Re: Terminal 4 Stormwater Source Control Measures – 100% Design Plan Sets and Operation and Maintenance Plans for Vegetated Infiltration Basins

1. 100% Plan Set and O&M Plan– Basin M Source Control Measure
2. 100% Plan Set and O&M Plan – Basin K1 Source Control Measure
3. Response to DEQ Comments Matrix on 60% Plan Sets

DISC. SHT. NO. C6.01

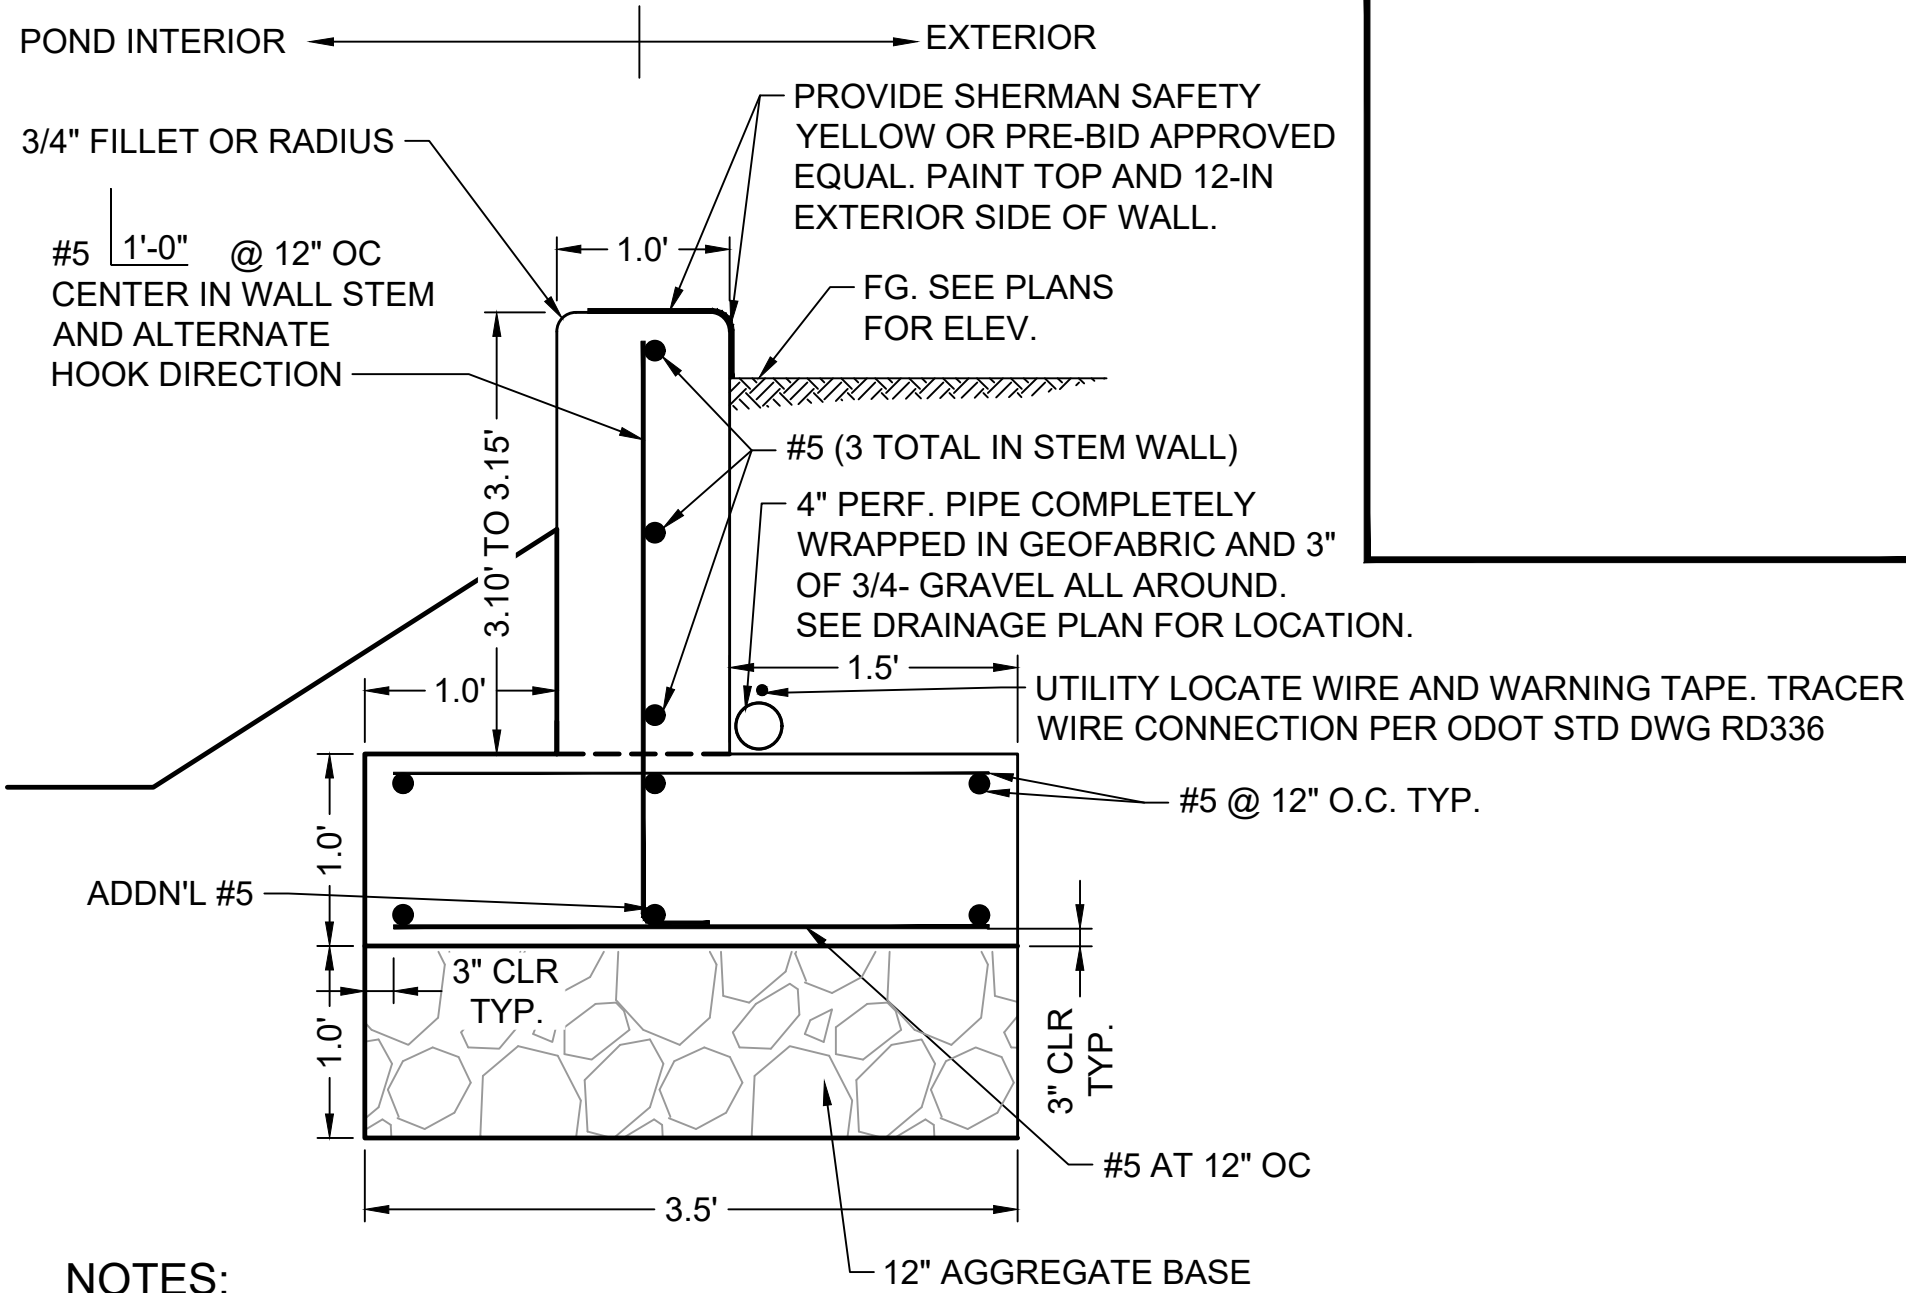
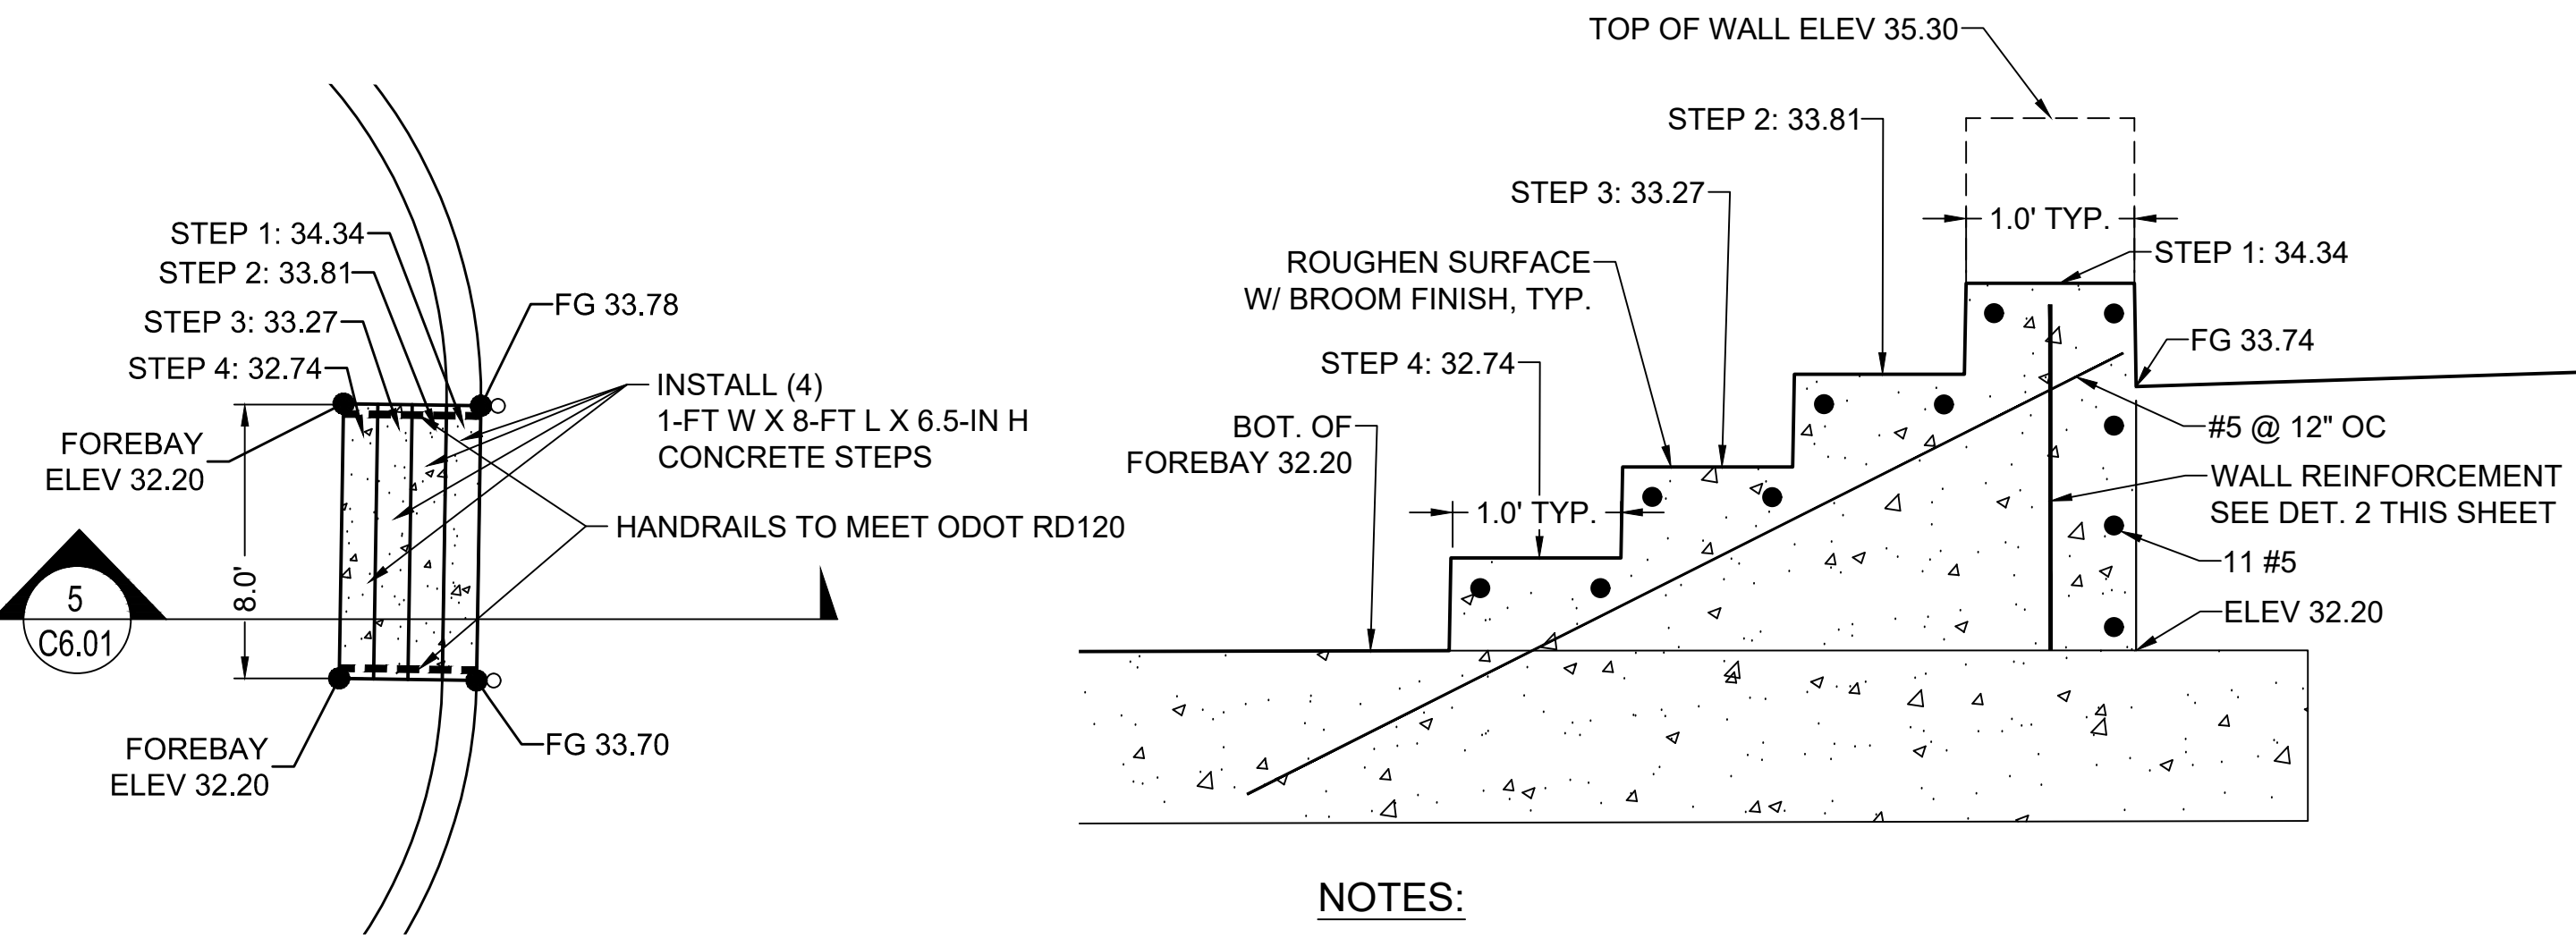
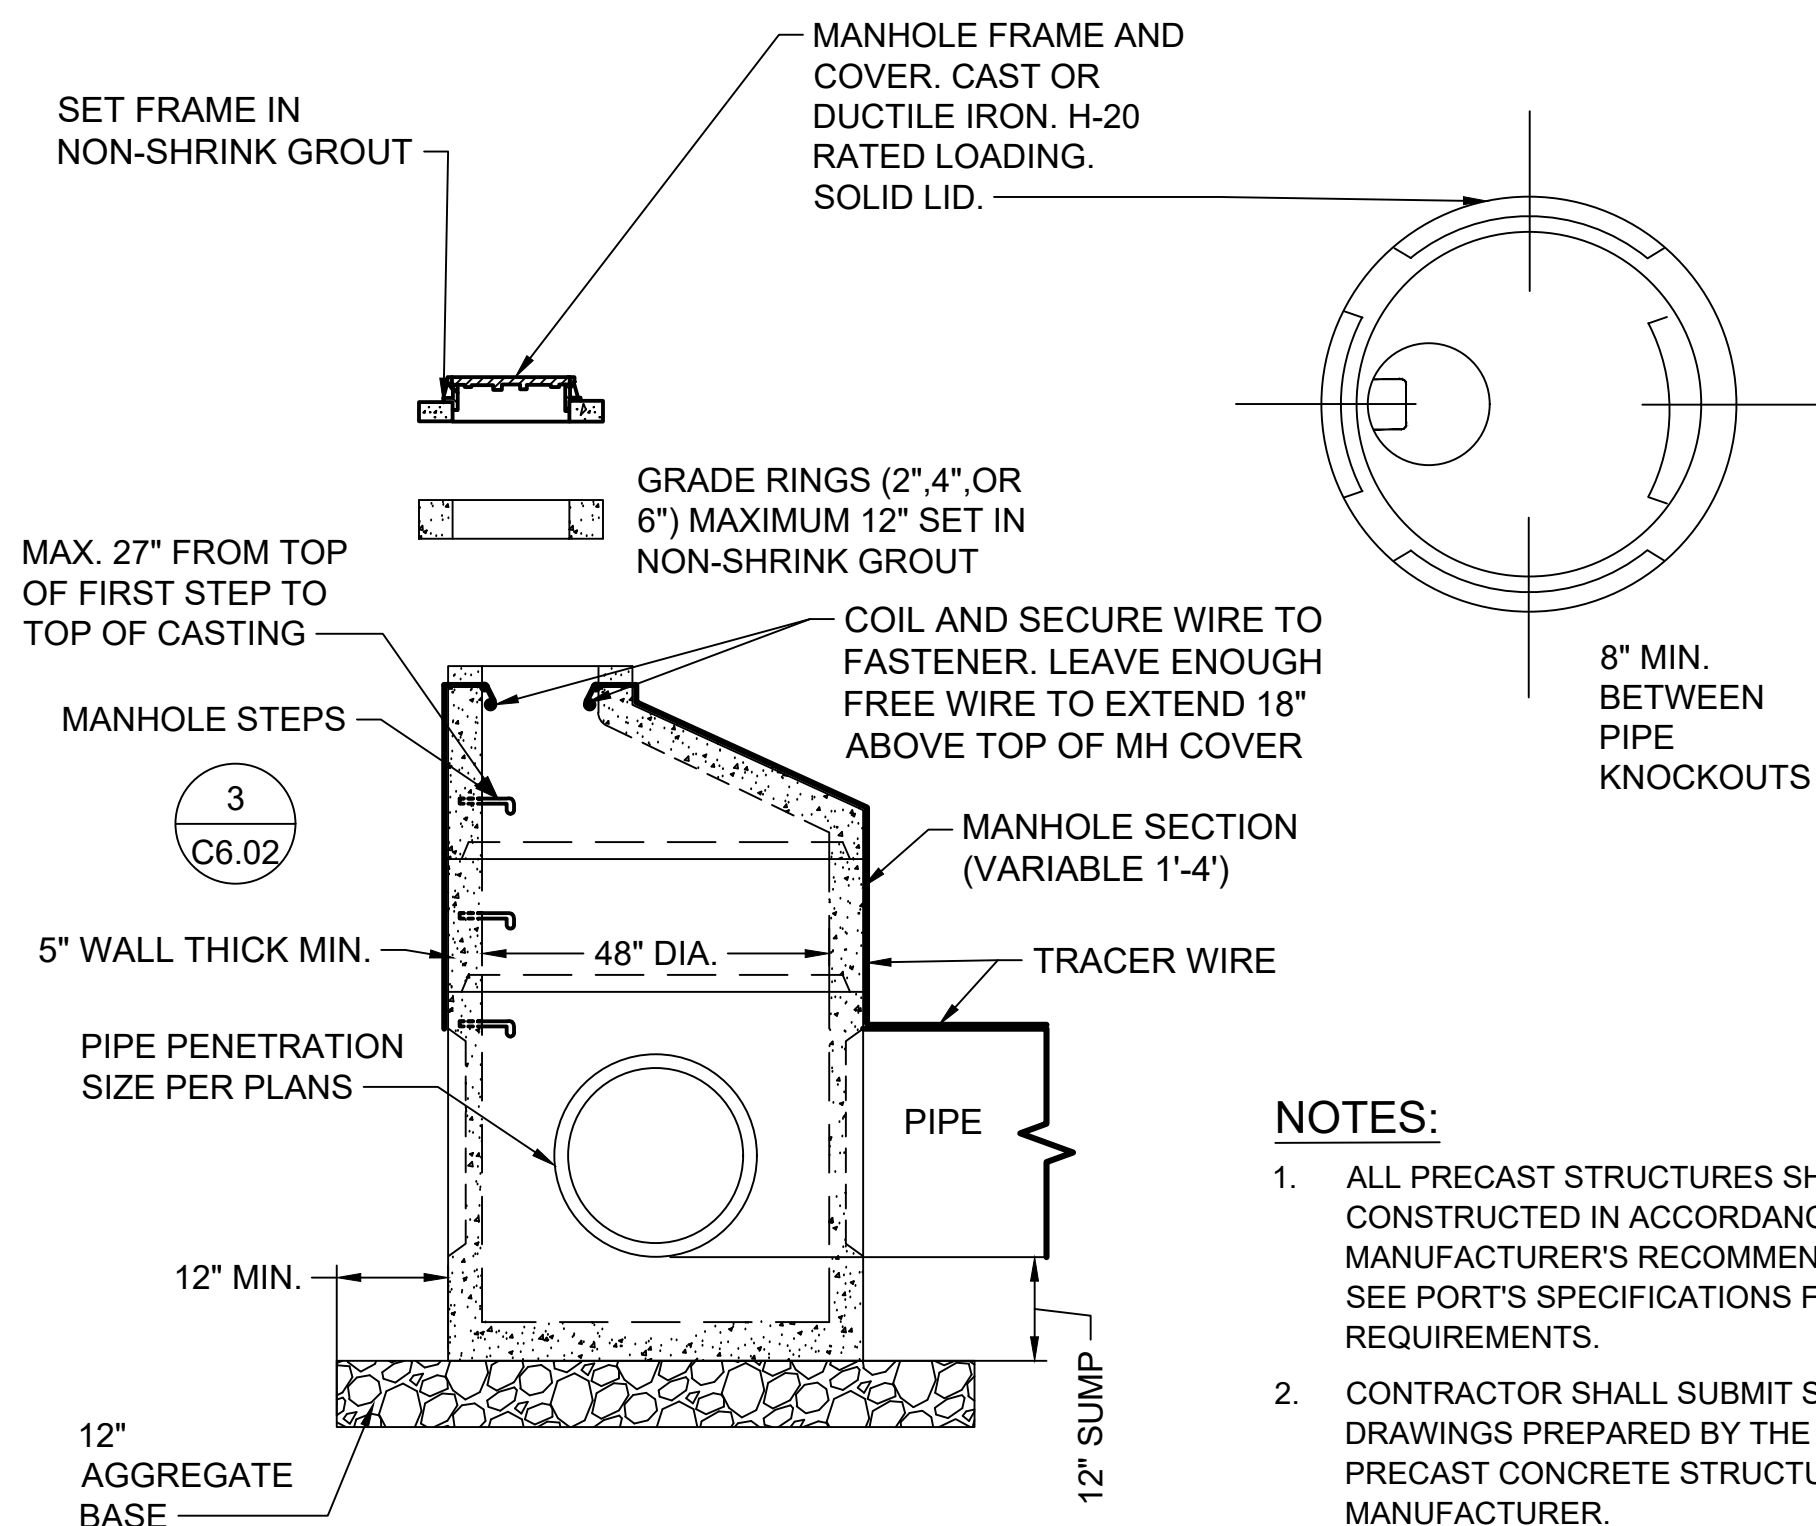
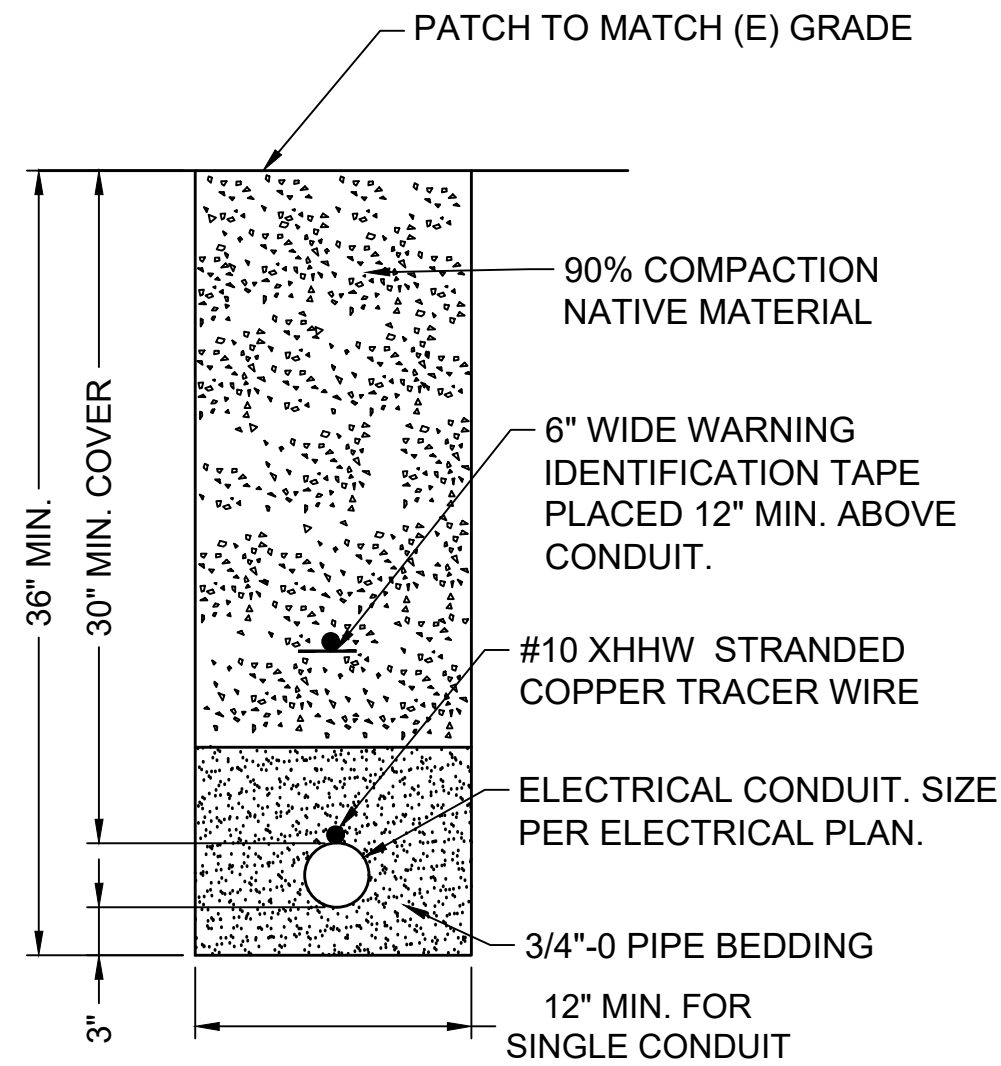
6 - Specific Comments – Basin M	60% Plans Sheets C6.01, L1.02	6. Sheet C6.01 Civil Details 1 – DEQ understands that additional details will be developed in the 100% design plan. However, please add the following information to this sheet to help clarify the design: a. The elevation of the force main outlet; b. The location and dimensions of the rip-rap pad below the weep hole pipes;	Sheet C6.01 in the 100% design plans has the requested information and distinguishes between engineering fill and planting media in a consistent manner on Sheet C6.01 and L1.02.

c. The difference/distinction between engineering fill and planting media. As a related point, this plan shows 24 inches of engineered fill at the bottom of the basin while the landscaping plan (Sheet L1.02) shows 18 inches of growing medium; d. The size specifications for the rip-rap and fill materials.	
7 - Specific Comments – Basin K1	60% Plans Sheets C2.01	7. DEQ suggests that the design plans for the basin K1 (Port) SCM should include a sheet similar to sheet C2.01 for basin M (Port), which provides a conceptual overview of the major system components.	See Sheet C4.0.
8 - Specific Comments – Basin K1	60% Plans Sheets C3.0	8. Sheet C3.0 Erosion and Sediment Control - Based on the inferred overland flow in the area of the basin K1 (Port) SCM, it is unclear why silt fencing was not proposed on the down-gradient side of the work area.	Silt fencing extent and location was revised, see Sheet C3.0.
